SUBJECT: Forwards proposed changes to FSAR Sections 1.9, 2.4, 6.3, 1.4, 15.1.5 & app 15C incorporating results of main steam line break analyses. Changes will be incorporated into next FSAR amend per NRC approval.

Subject: Palo Verde Nuclear Generating Station (PVNGS)  
Units 1, 2, and 3  
Docket Nos. STN 50-528(License No. NPF-41)/529/530  
Main Steam Line Break Analyses Results - Chapter 15 Reanalyses  
File: 85-056-026; G.1.01.10

The results are presented as proposed changes to FSAR Sections 1.9.2.4, 6.3.1.4, 15.1.5 and Appendix 15C and are all within NRC acceptance criteria. Upon NRC approval, these FSAR changes will be incorporated into the next PVNGS FSAR Amendment.

Figure 15.1.1-6

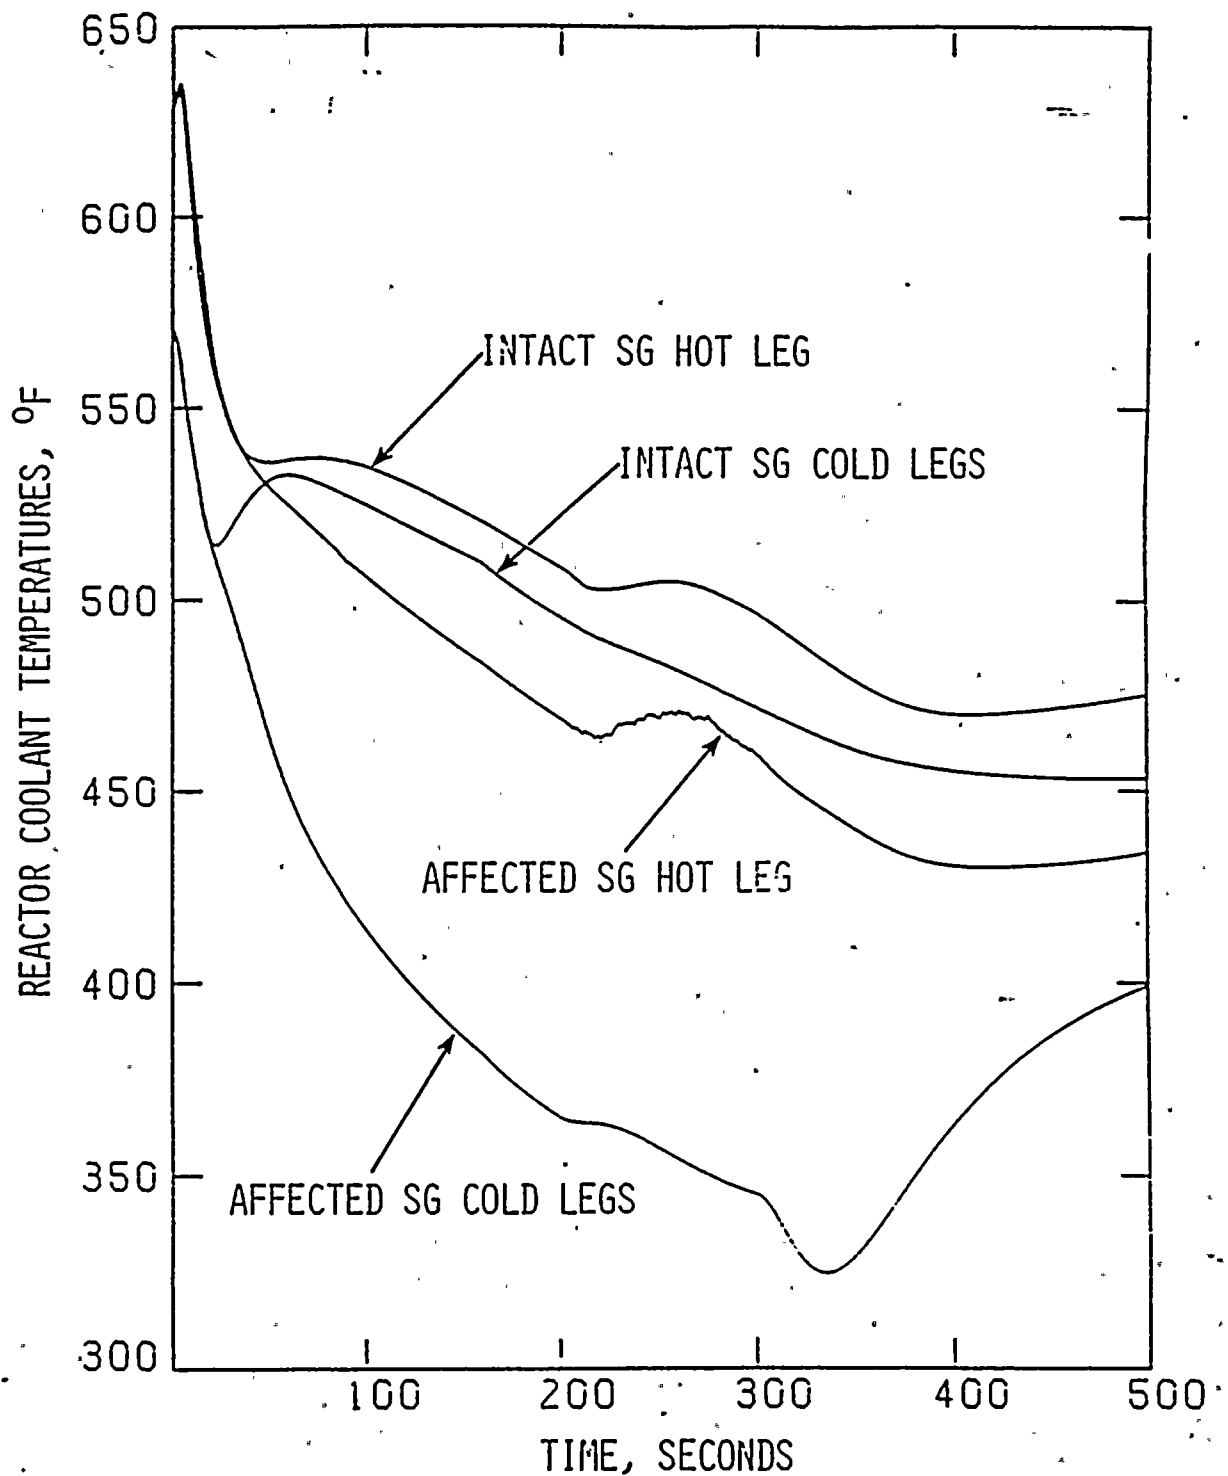
Replace with Figure 15.1.1-7

Figure 15.1.1-7

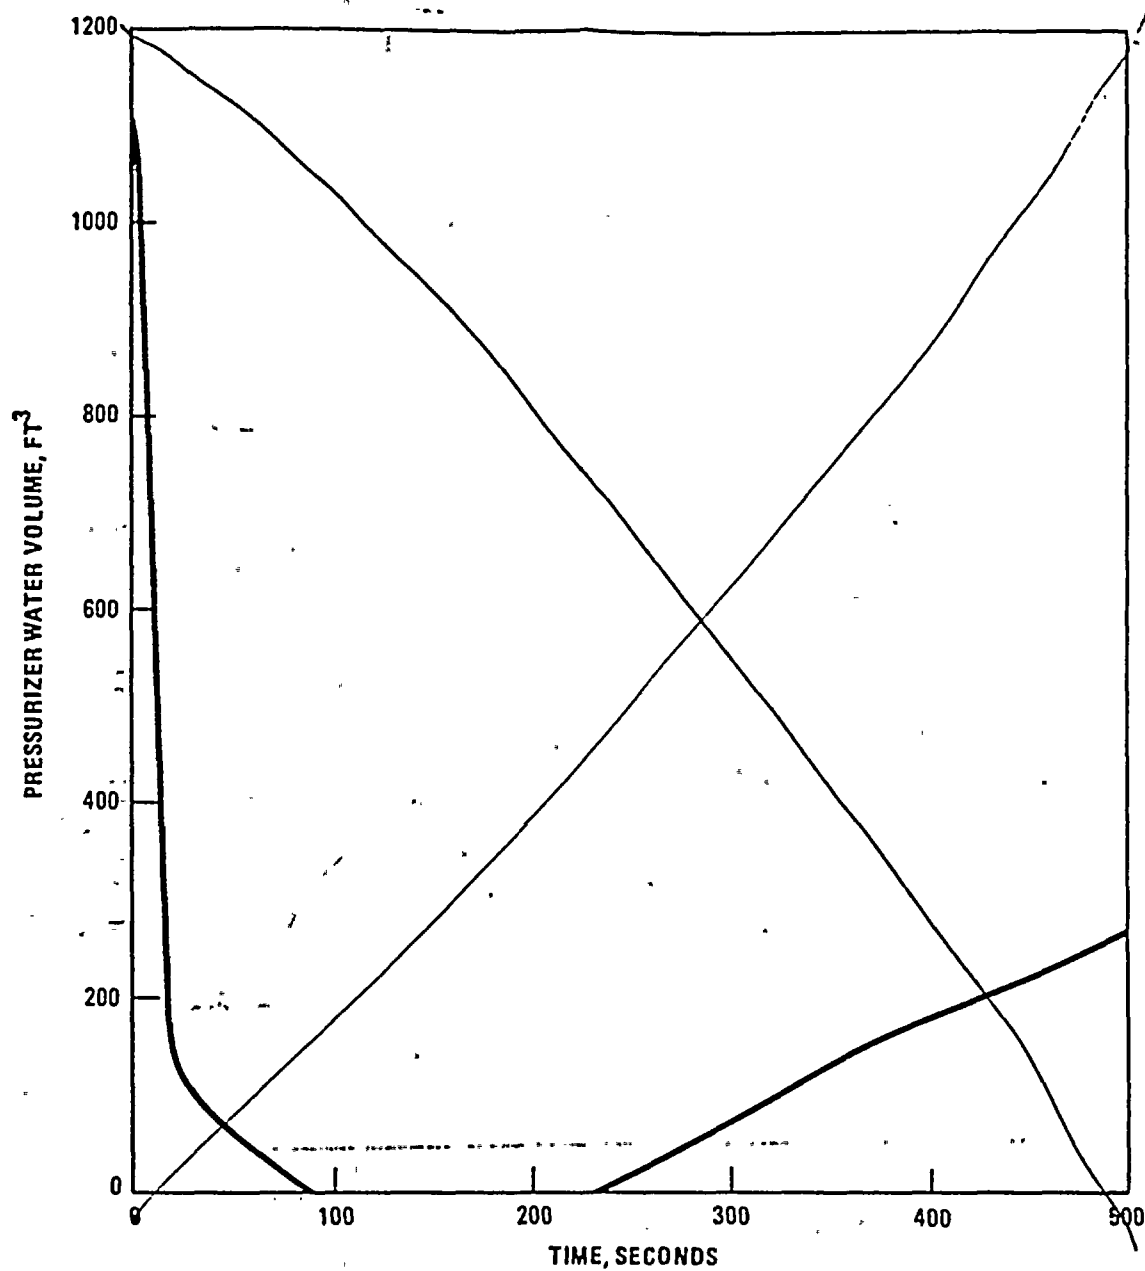
Replace with Figure 15.1.1-8

Figure 15.1.1-8

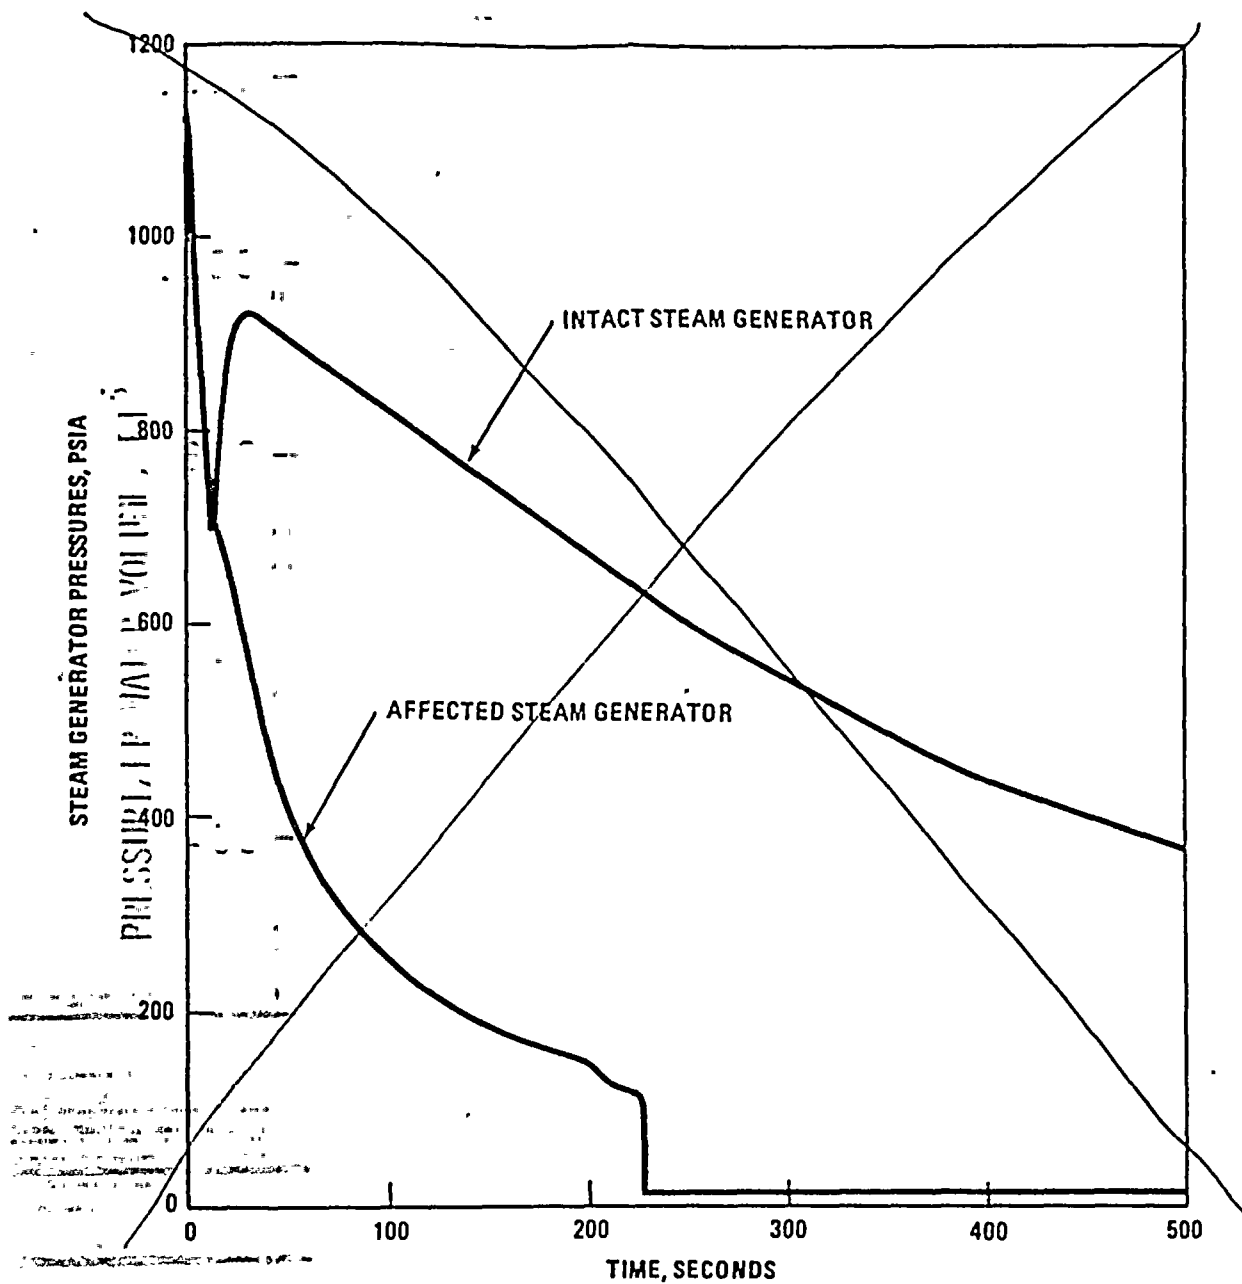
Replace with Figure 15.1.1-9

Figure 15.1.1-9

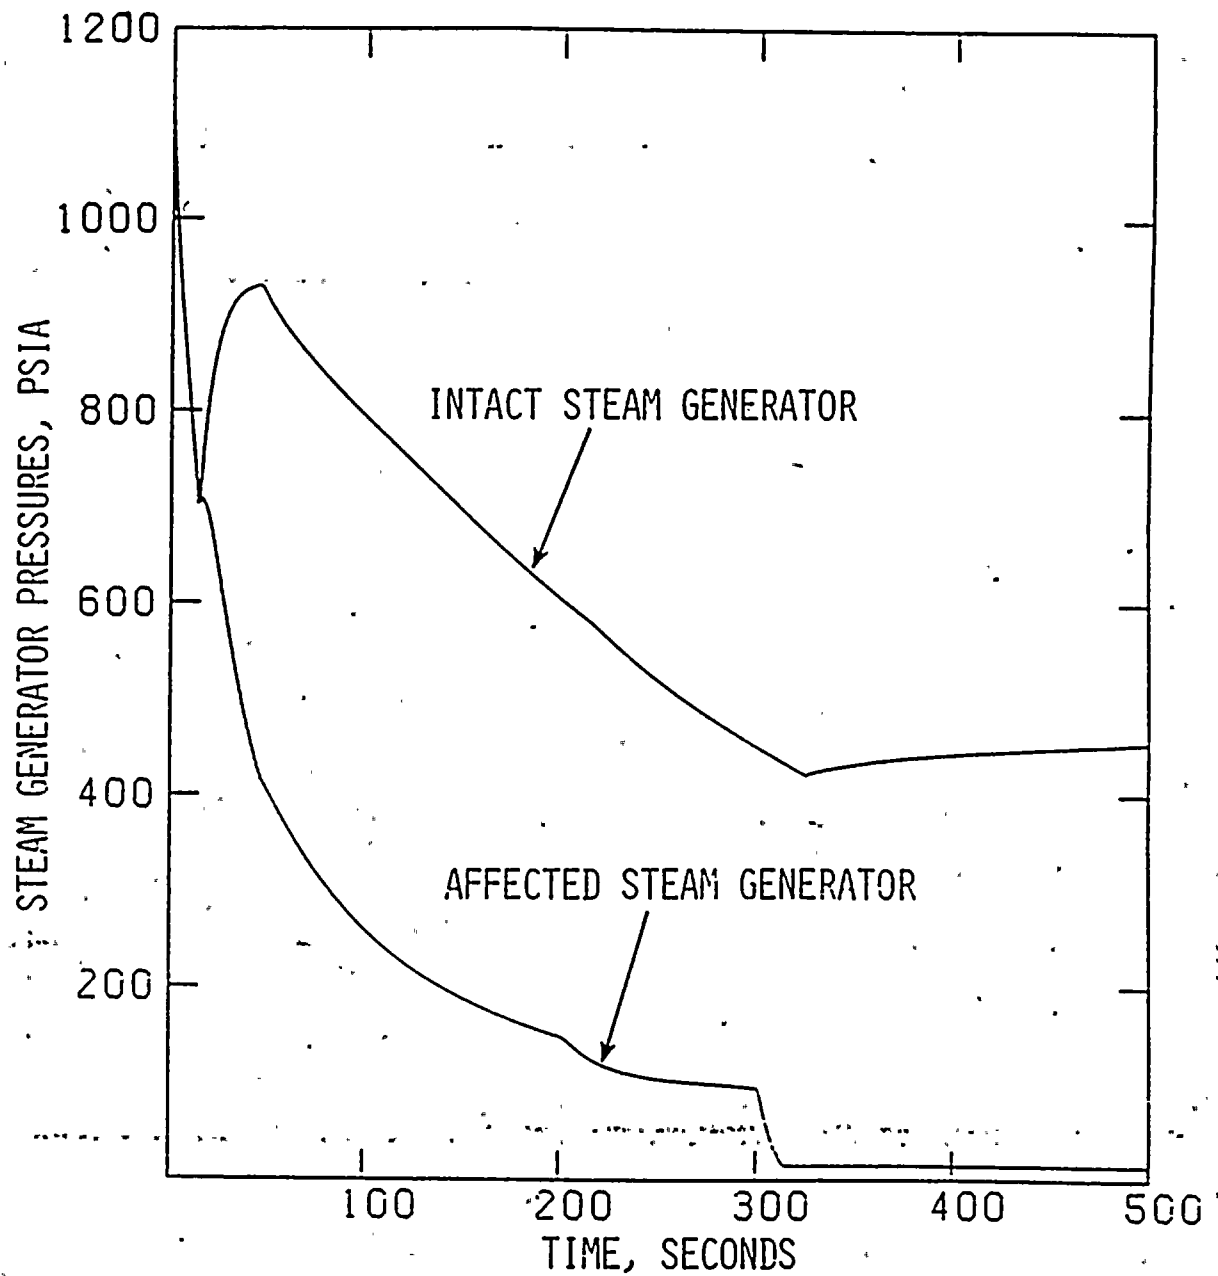
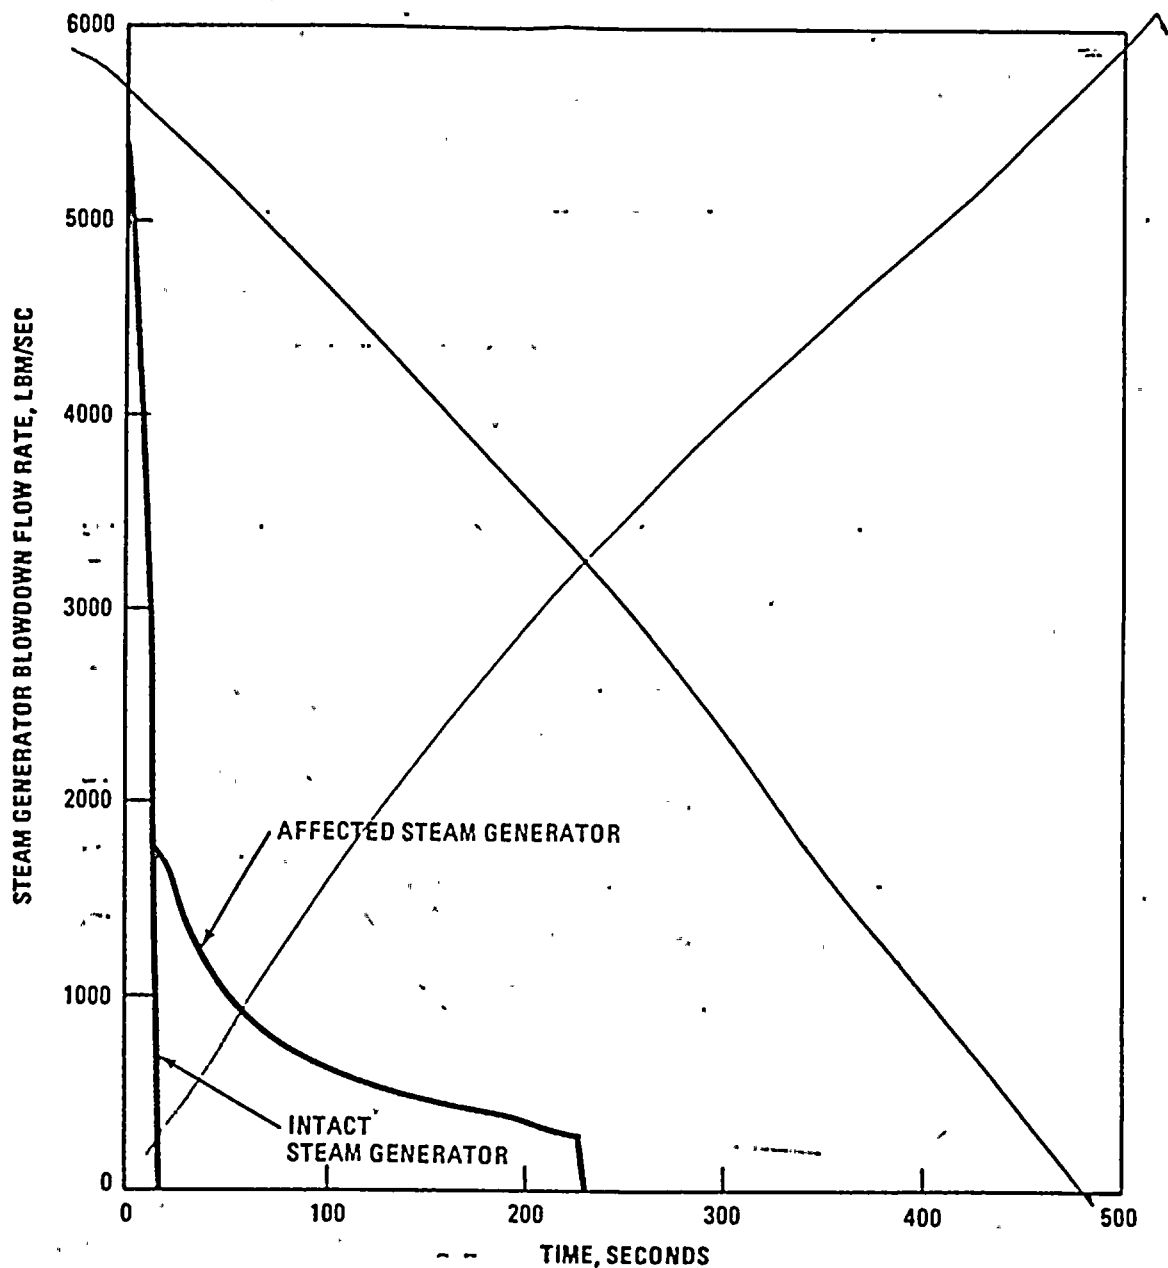
Replace with figure 15.1.1-10

Figure 15.1.1-10

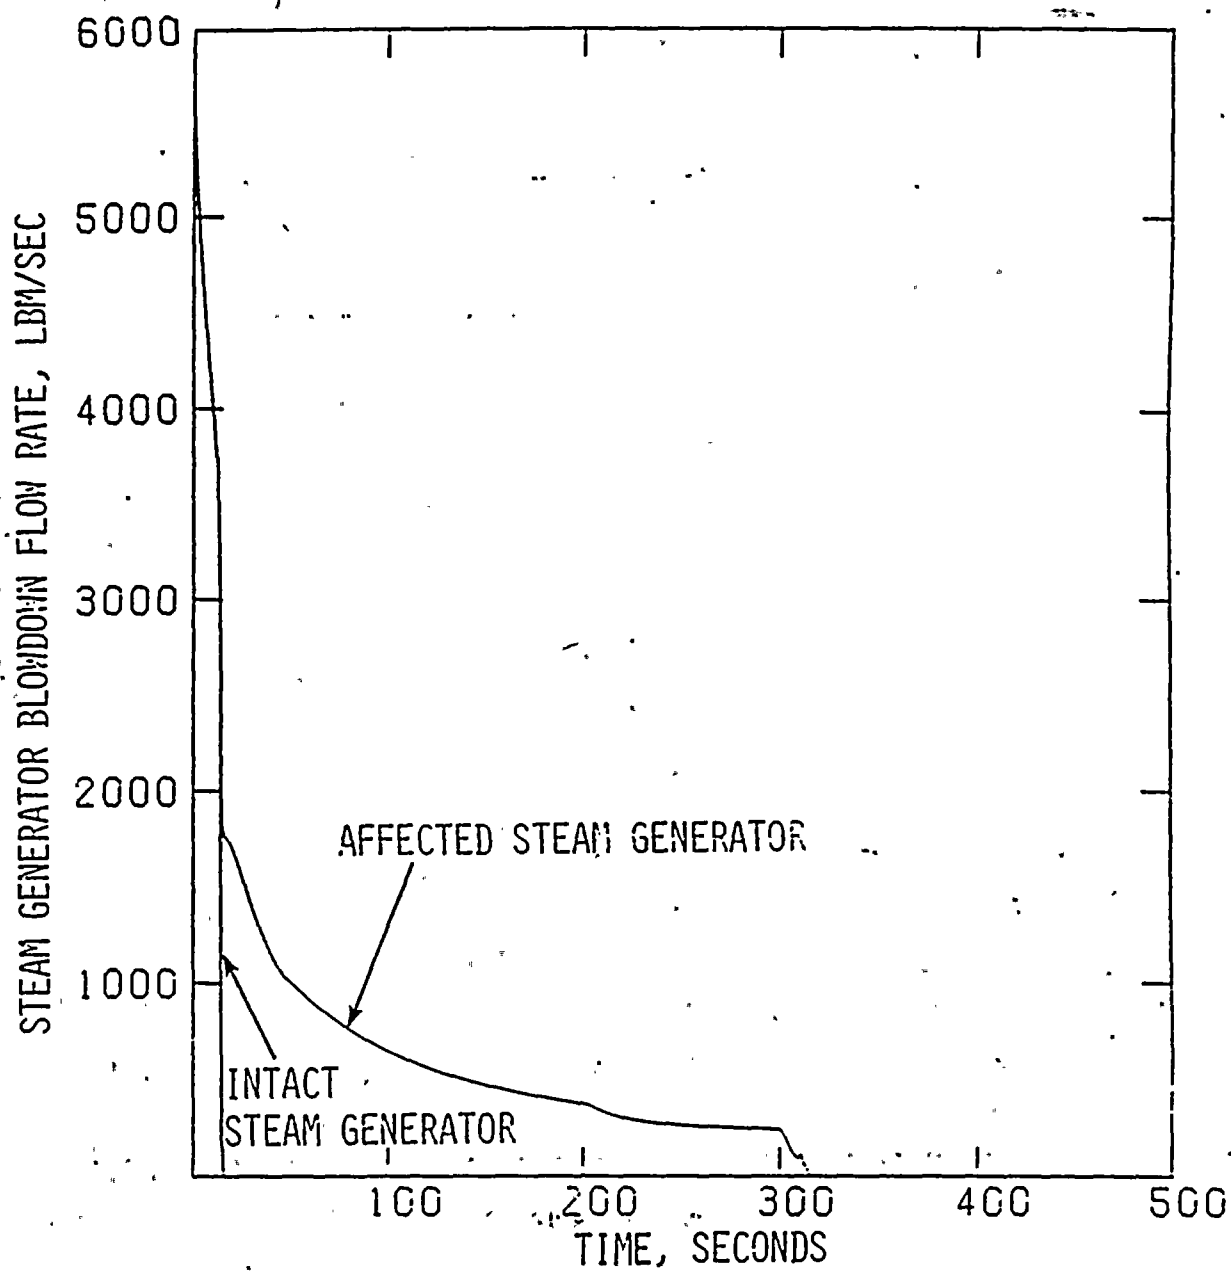
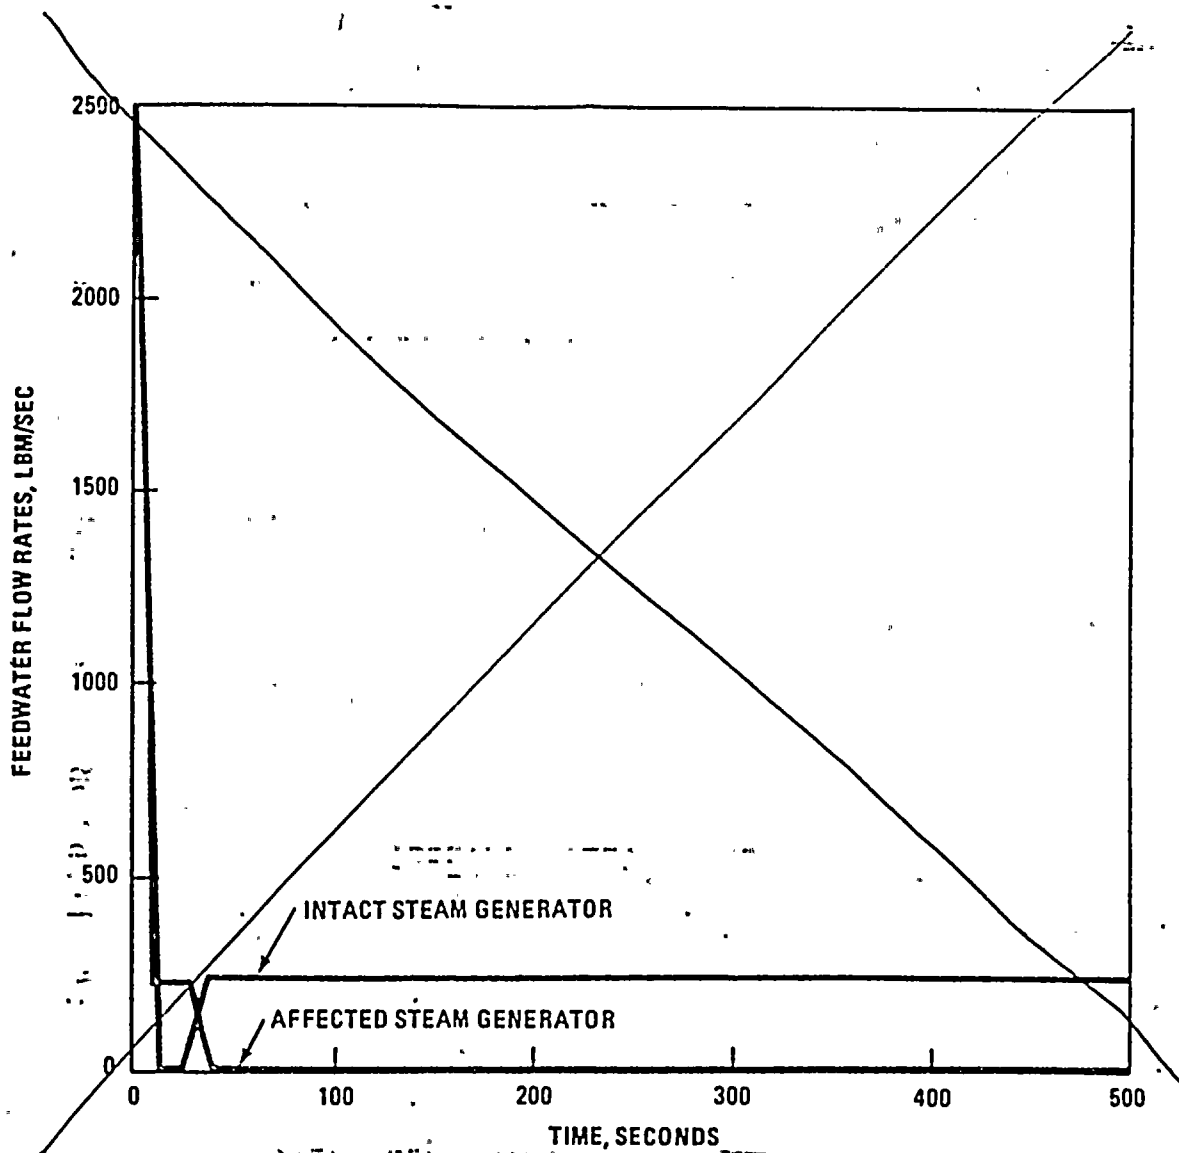
Replace with Figure 15.1.1-11
